From: Archer, Zach (Consultant)
Sent: Monday, April 6, 2026 10:40 PM
To: Ng, Gabe (Consultant) <Gabe.Ng@consultant.wsdot.wa.gov>; Berriz, Sonia (Consultant) <Sonia.Berriz@consultant.wsdot.wa.gov>
Subject: Juanita Creek Lateral Migration - Draft Response to LTR 384

I am preparing the response to Skanska LTR 384 regarding Juanita Creek lateral migration. The letter includes a detailed chronology of the design review process and task force minutes from January through July 2025.

Subject: RE: I405 BY: RSCR Comment Follow Up

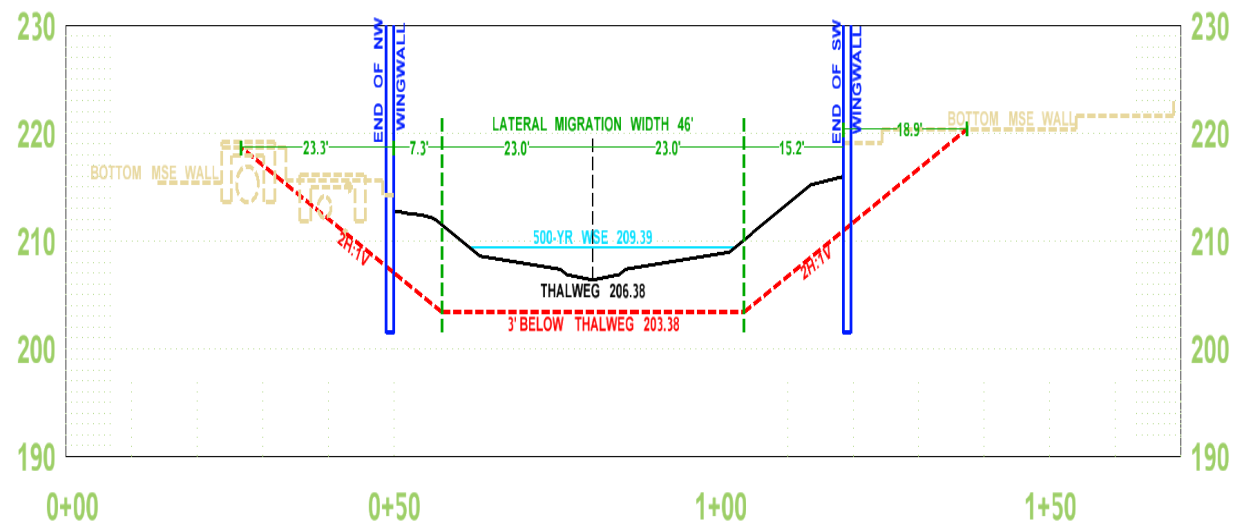
Thank you for the quick response! Here is the updated section view of the scour prism at the downstream end of the wingwalls (at the MSE wall), looking upstream. We will use this as a guide to design buried riprap following HEC-23 to protect the MSE wall.

Note that I updated the lateral migration extents figure below to match the one in the spreadsheet (there was a minor difference).

Figure X. Juanita Creek Design Reference Reach Lateral Migration Extents

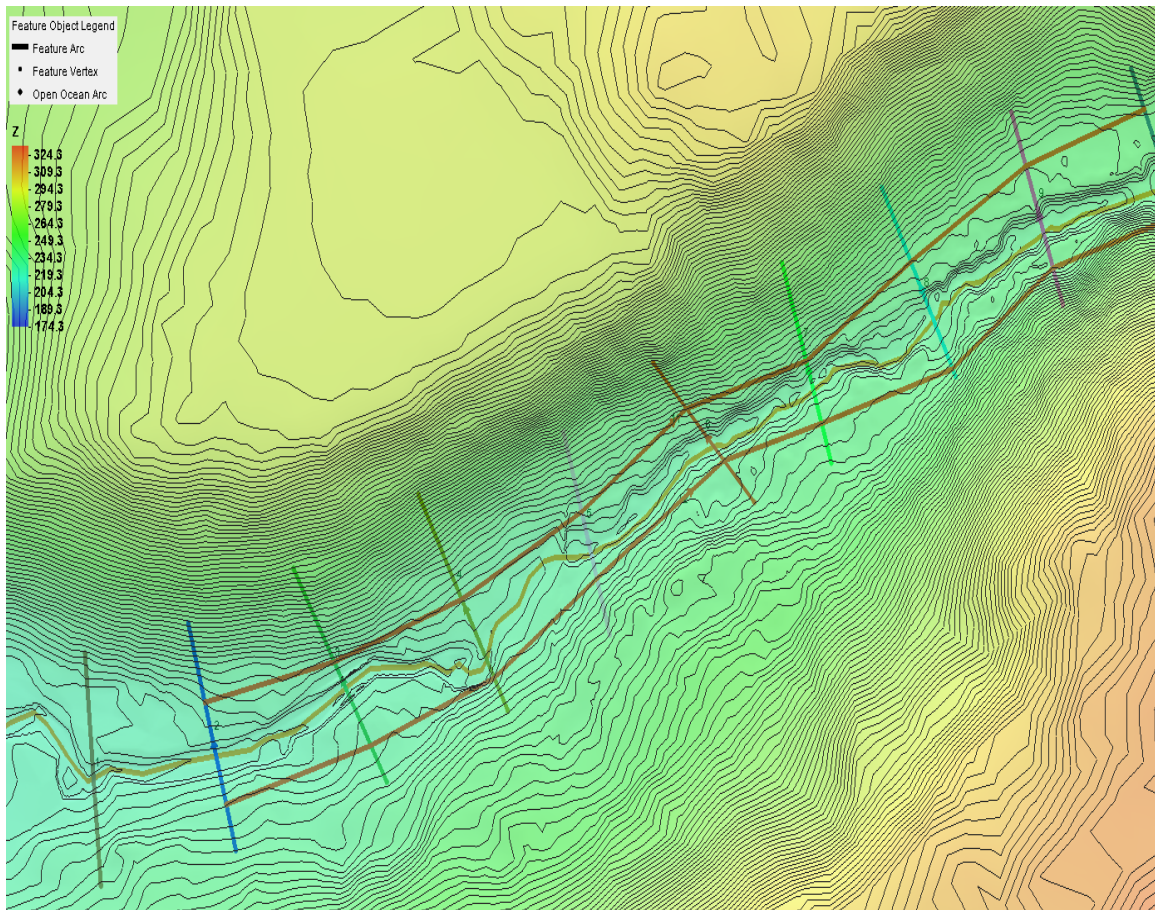
We would like to come to a consensus on lateral migration extents for Juanita Creek as soon as possible, since this impacts other disciplines. We performed an updated valley width analysis for Juanita Creek, something we discussed with Gabe several months ago (Alex, I don't think you were on that call). We looked at cross sections in the design reference reach and estimated a conservative average width of **46.0 feet**. We propose to use this value for lateral migration extents. This is wider than the 30-foot meander belt width estimated by WSDOT for preliminary design, wider than the proposed tunnel width (37.8 feet), and wider than proposed 500-year extents downstream near the MSE wall.

To determine the lateral migration extents for Juanita Creek, valley width measurements were estimated for the design reference reach. Cross sections were cut for the nine upstream BFW locations (the most downstream BFW location was not used because it is near the bend in the creek where the valley floor widens in the wetland area). Valley width extents were estimated by analyzing grade breaks on the banks of the cross sections. They indicate the horizontal extent of the valley floor, which includes the river channel and associated floodplains and terraces. These are indicative of the extents that the channel could potentially migrate. The average valley width for the nine cross sections is 46.0 feet. This value will be used as a conservative estimate for the lateral migration extents. The figure below shows lines connecting the valley width extents for the 9 cross sections through the design reference reach. Appendix N [attached spreadsheet] shows the cross sections for each of these locations along with the valley widths.

The tunnel and wingwalls are designed for full scour depth and do not require scour protection. We propose to use this lateral migration extents to design scour protection for the MSE wall, using the extents to determine how much of the MSE wall will need to be protected .

This looks good. Thank you. I agree with your estimate of lateral migration extents and documentation. Please include this information in the final FHD.

Junita Creek 500-yr extents:

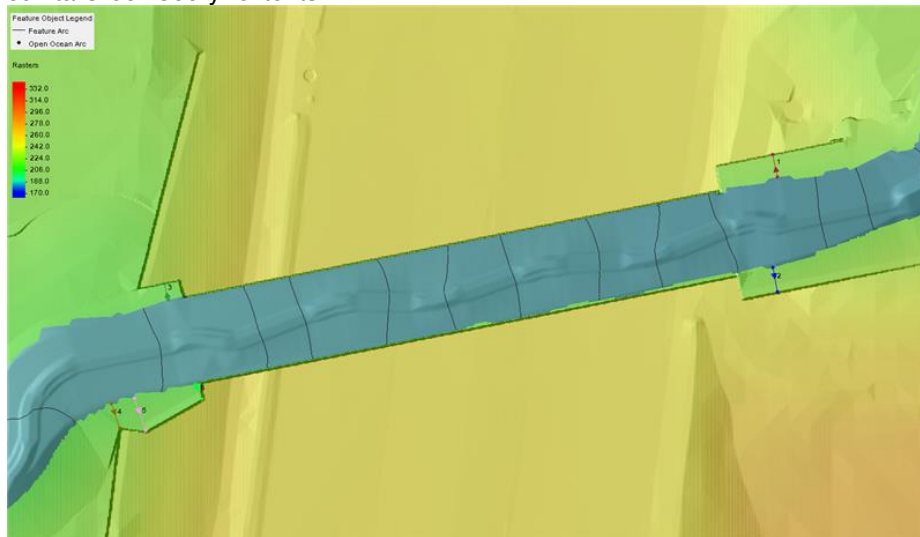
- The flood prone width (which is defined as the water surface width at twice the bankfull depth or the width at the 50-year to 100-year flood) can be considered as a proxy for the channel migration zone and the extents of lateral migration. The FPW was calculated as 18.1 ft in the upstream reach and 17 feet in the downstream reach, based on the 100-yr model results.

- We propose that the modeled **500yr extents be considered the extent of lateral migration**.

Juanita scour prism at MSE wall:

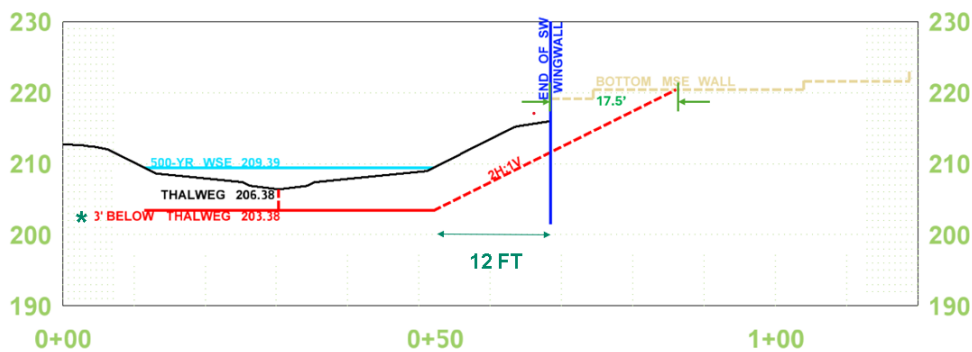
- Regarding the structures, **both tunnel and wingwalls are designed for full scour depth**. FHD did not include scour countermeasures to be provided on top of that.

*calculated total scour = 1.1 ft
